DEVIATION REQUEST AND DECISION FORM

Project Name : The Ridges at Lorson Ranch

A deviation from the standards of or in Section **2.3.2** of the Engineering Criteria Manual (ECM) is requested.

Exhibit 2

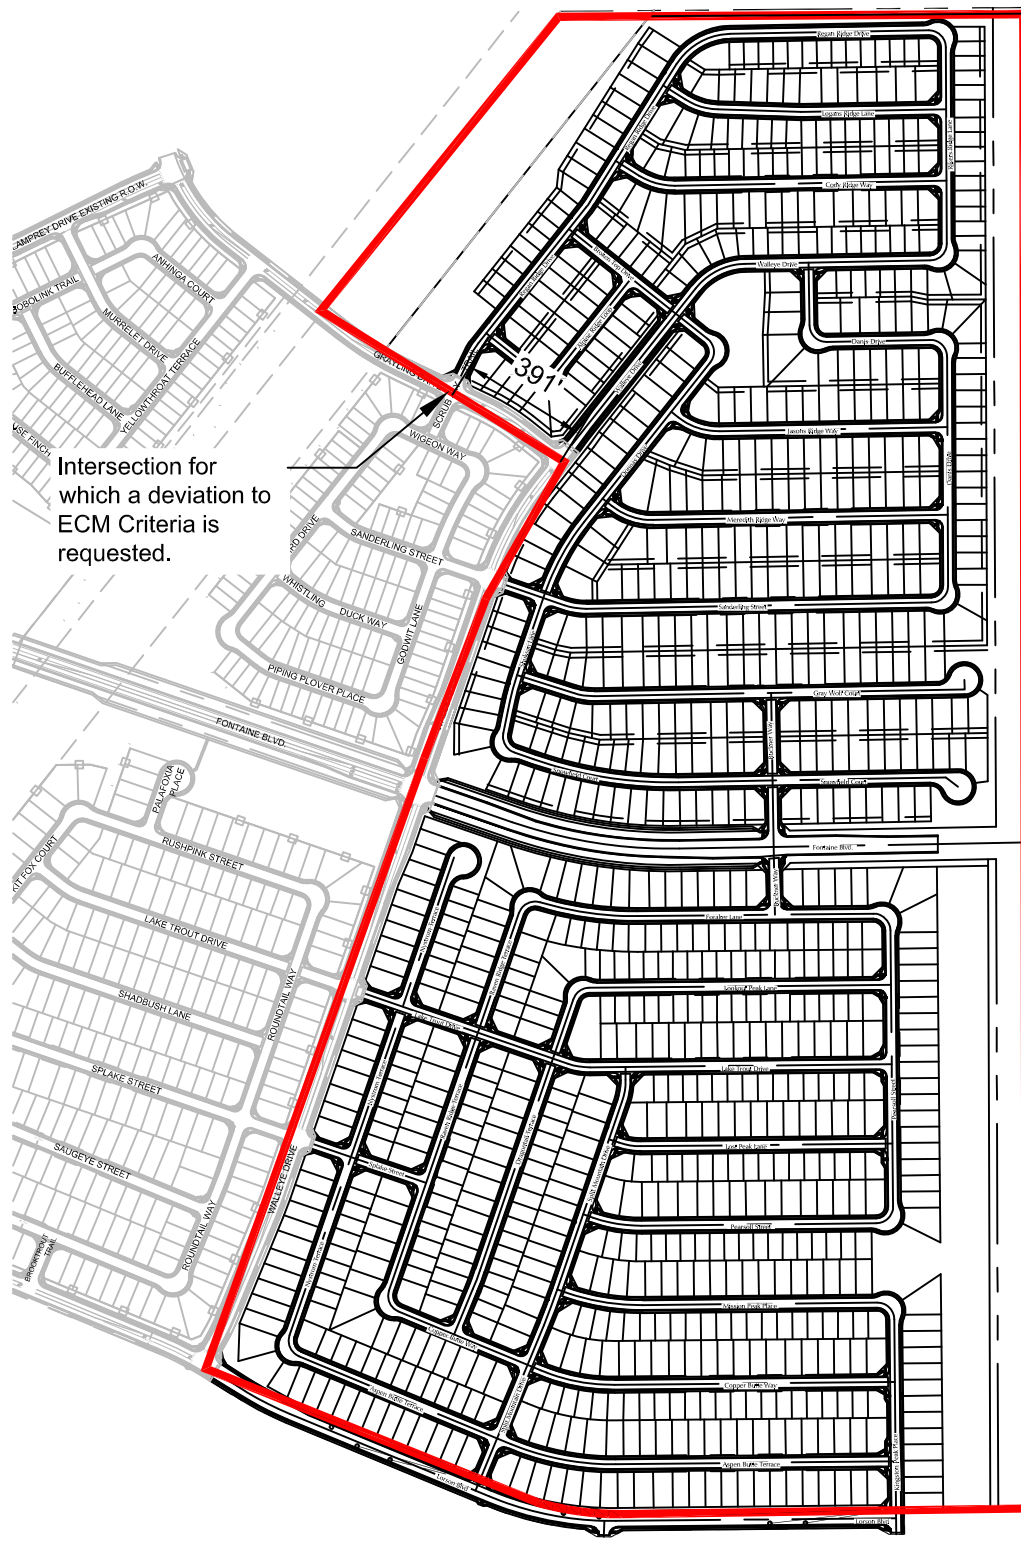
The intersection of Regan Ridge Drive/Grayling Drive is proposed about 391 feet east of Walleye Drive (centerline to centerline). As shown in **Exhibit 2** this configuration provides 356 feet of available intersection sight distance. This is 89 feet less than the *ECM* criteria.

The available intersection sight distance from Regan Ridge Drive/Grayling Drive to Walleye Drive is about 356 feet. The required intersection sight distance from Table 2-21 of the *ECM* is 445 feet, based on a design speed of 25 miles per hour (mph). As Grayling Drive/Walleye Drive is a "T" intersection, all westbound traffic on Grayling Drive approaching Regan Ridge Drive will have either just turned right or left from Walleye Drive. The turning speed for these movements is likely between 9 and 20 mph. The intersection sight distance requirement for a roadway with a posted speed limit of 25 miles per hour shown in Table 2-21 is 280 feet. Based on the lower travel speed, the 356 feet of available sight distance will be adequate.

This request has been determined to have met the criteria for approval. A deviation from Section 2.3.2 of the ECM is hereby granted based on the justification provided.

Additional signage may be required to be installed by developer at the time of construction or afterwards if issues arise due to traffic speeds.

Exhibit 1
Deviation Request Location
Ridges at Lorson Ranch (LSC #S214080)

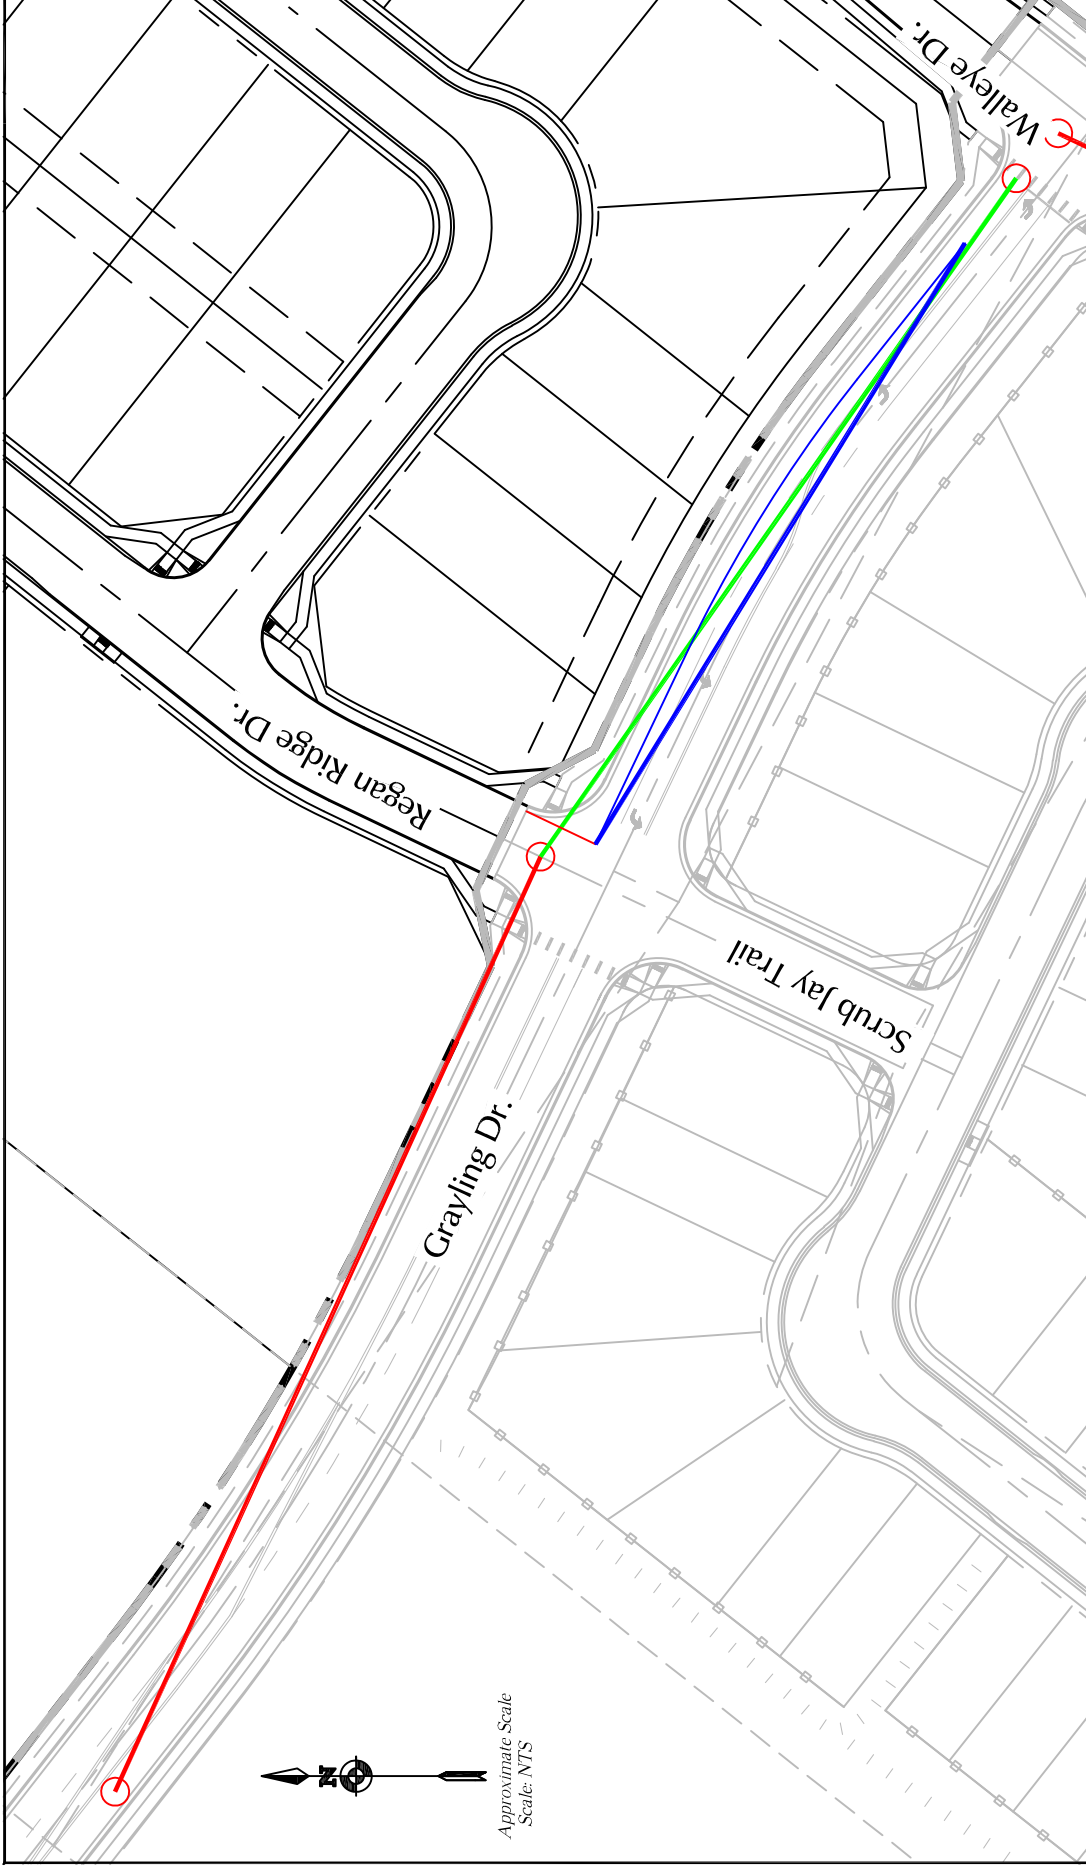
Exhibit 1 shows the location of the intersection (Regan Ridge Drive/Grayling Drive) for which the deviation is requested.

Intersection for which a deviation to ECM Criteria is requested.
